Objection to Planning Application- 2022/1874/P from David Lewisohn

I have lived at 33A Dartmouth Park Avenue since 2005. I live next door to the subject of the application, 33 Dartmouth Park Avenue.

Page 4: Side Elevation Plan marked A-B to show the true height of the wall at time of submission of the Application, and marked C-D to show height of wall as shown on Elevation Plan.

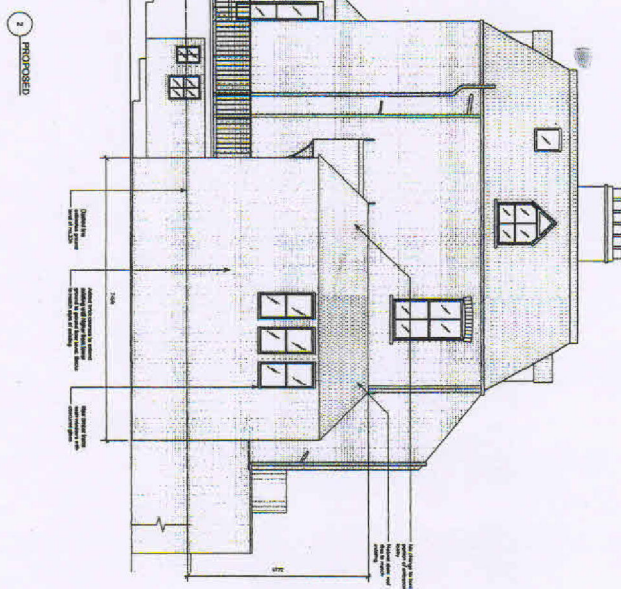
- (A) The Side Elevation Plan submitted as part of the application does not show the actual height of the brick boundary wall between the properties

The height of the boundary wall (shown on both the Existing and the Proposed drawing on the Elevation Plan) is not correctly drawn. The wall at the time of submission of the Application was between 1.1 & 1.52 metres high (the ground slopes towards the garden) measured from the 33A DPA side of the wall – not, as shown on the plan, a height of approximately 3 metres. So the plan gives the impression that increasing the height of the wall would be much less intrusive than in fact would be the case.

I attach the Side Elevation Plan on which I have marked A-B the true height of the wall measured from 33A DPA at the time of submission of the Application, and C-D the height of the wall as incorrectly shown on the plan. (See page 4)

Page 5: Rear Elevation Plan marked to show the rear of the Utility/Workroom.

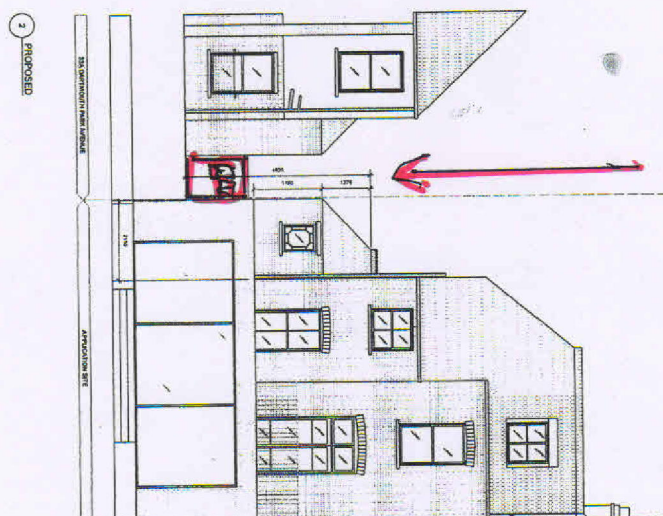
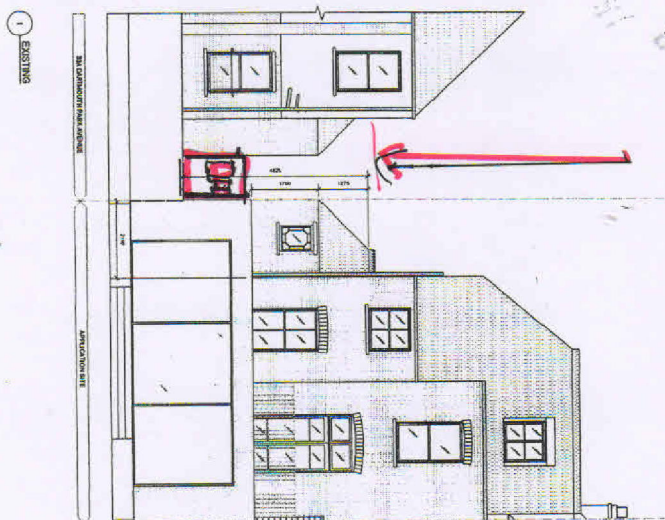
- (B) The Rear Elevation Plan is incorrect and misleading in that it does not show the Utility Room/Workroom at 33A DPA. This is single-storey low-ceilinged structure with a front wall facing the street which is stucco faced brick with an entrance door but no window, and a rear wall with door and windows facing the garden at 33A DPA. **This is a room at 33A DPA which is in constant use, and is the room that would be most affected by the proposed works, but it is not shown on the plans submitted to you.**

I attach the Rear Elevation Plan on which I have marked in red the outline of the rear of the Utility/Workroom. (See page 5)
